**IN THE MATTER of resource consent
applications 220120 &
230030 at 117
Arthurstown Road,
Hokitika**

BY Forest Habitats Ltd

STATEMENT OF EVIDENCE OF STUART CHARLES CHALLENGER

8 April 2024

Figure 1. Subdivision Layout and Landscape proposal overlaid by Tsunami Evacuation Zones.

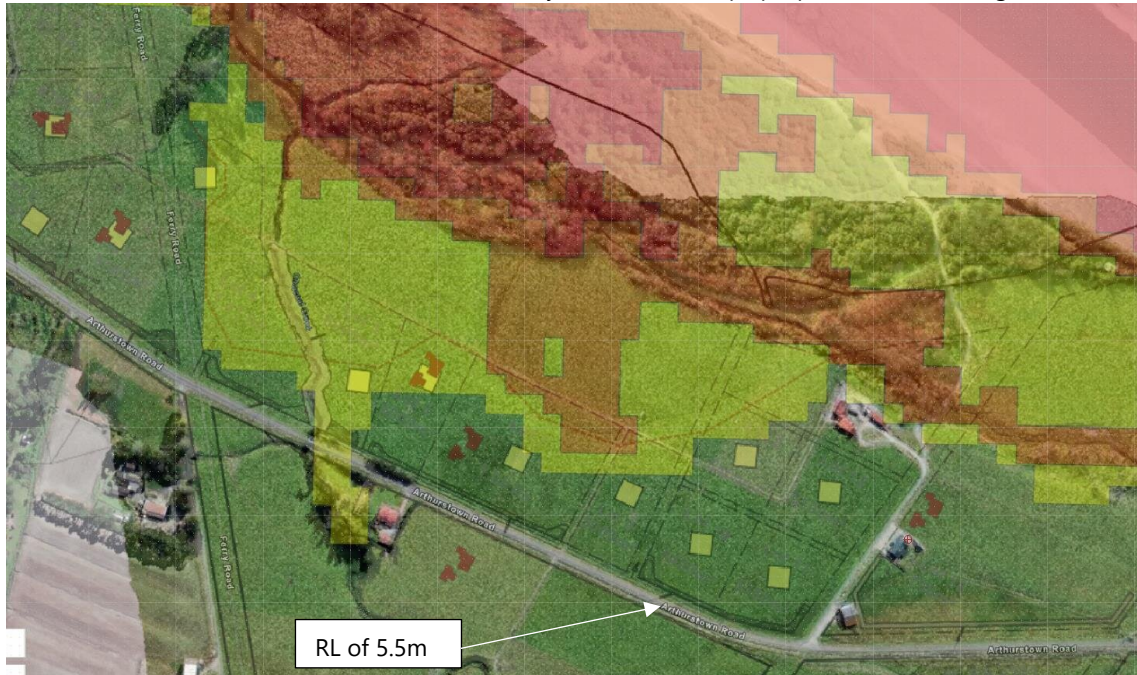
Paragraph 4.17

- 4.1 The Section 42 report notes that the NEMA information has not been provided. Appendix D includes a screen grab of the National Emergency Management Agency, Tsunami Evacuation zones for Hokitika and the applicant's site.
- 4.2 To provide better clarity on the potential threat from a tsunami on the proposed subdivision I have overlaid the Tsunami Evacuation zones on the Subdivision Layout and Landscape proposal. Shown on Figure 1, below.

- 4.3 Figure 1 shows the projected tsunami threat based on the current ground profile, as potentially impacting building platforms on Lots 4, 5 and 6, which are shown as being in yellow evacuation zone (greater than 5m tsunami wave threat). However, once the building platforms have been completed, they will be above the evacuation zone so they will not be at risk. The building platforms will be at a similar level to the height of Arthurstown road about 50m west of its intersection with East Road.

- 4.4 The proposed Lots will be accessed from Arthurstown Road and East Road, which are not shown as being in a Tsunami Evacuation zone. It is recommended however, that the driveway to lot 5 be raised in order that safe access can be provided in the event of tsunami.
